# FirstEnergy – FE East Yards Creek Pumping [SPS] Retirement Proposal

FirstEnergy, Transmission Planning  
August 2017

# Area Major Transmission Facilities

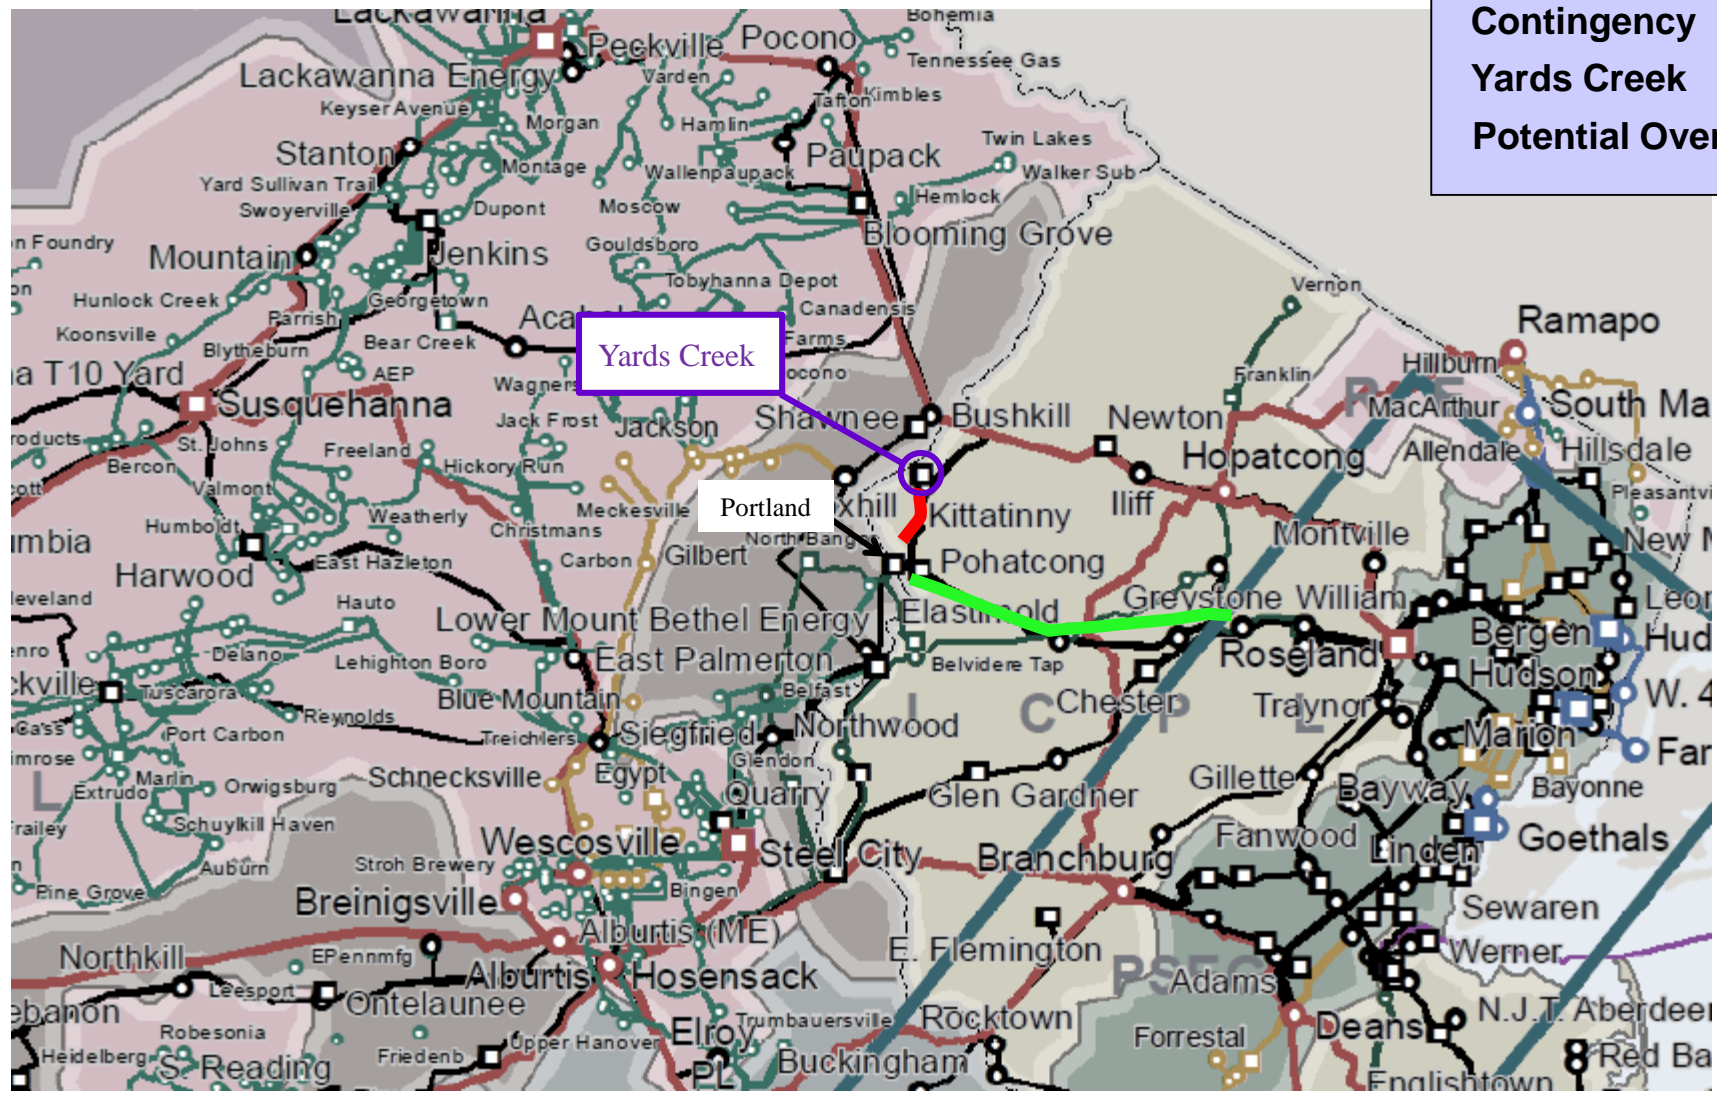
**Contingency** —

**Yards Creek** —

**Potential Overload** —
